Access Compliance Report

Public Rights-of-Way

(Curb Ramps)

Intersection ID: 25142	Main Street: COTTON_CREEK_DR	Cross Street: WEAVER_MILL_LN	Location: E
ADA ID: EB4479C8D811	Ramp Type: PerpDiag	Initial Pass/Fail: Fail	Overall Compliance: No
Severity Score: 21.25			
Codes/Mitigation Info/Possible Solution		Field Measurements/Component Compliance

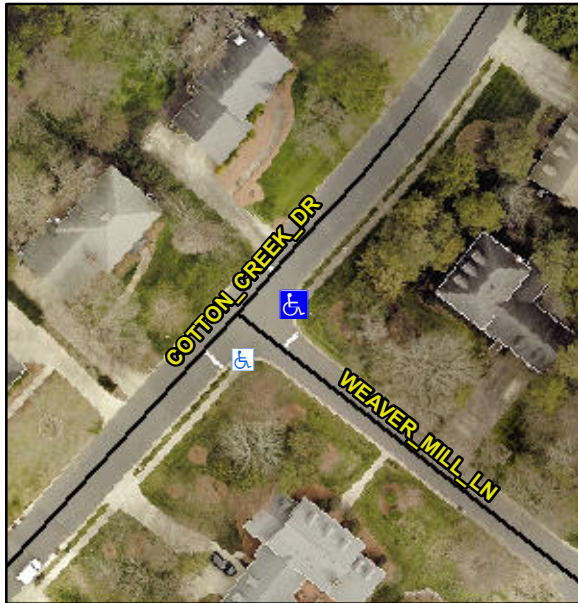
Not Found, R304.5.1, R304.2.2

Compliance	Description	Data	Compliance	Description	Data
N/A	Ramp Length (in)	48.0	No	Ramp Slope (%)	10.5
No	Ramp Width (in)	36.0	Yes	Ramp XSlope (%)	1.7
N/A	Flare Type LT	N/A	N/A	Flare Type RT	N/A
N/A	Flare Slope LT (%)	N/A	N/A	Flare Slope RT (%)	N/A
N/A	Flare Traversable LT?	N/A	N/A	Flare Traversable RT?	N/A
N/A	Landing Length (in)	N/A	N/A	DWS Provided?	N/A
N/A	Landing Width (in)	N/A	N/A	DWS Contrast?	N/A
N/A	Landing Slope (%)	N/A	N/A	DWS Length (in)	N/A
N/A	Landing X Slope (%)	N/A	N/A	DWS Full Width?	N/A
N/A	Landing Curb? (Y/N)	N/A	N/A	DWS Offset (in)	N/A
N/A	Shared Landing?	N/A			
N/A	Gutter Ponding?	N/A	N/A	Gutter Slope (%)	N/A
N/A	Gutter Lip Ht (in)	N/A	N/A	Gutter X Slope (%)	N/A
N/A	Painted X Walk1?	No	N/A	Painted X Walk2?	No
	X Walk 1 Direction	To NW		X Walk 2 Direction	To SW
N/A	X Walk 1 Width (in)	N/A	N/A	X Walk 2 Width (in)	N/A
	X Walk 1 Slope (%)	5.0		X Walk 2 Slope (%)	1.1
	X Walk 1 X Slope (%)	0.2		X Walk 2 X Slope (%)	6.1

Remove & Replace Curb Ramp With Two New Directional Ramps or Equivalent.
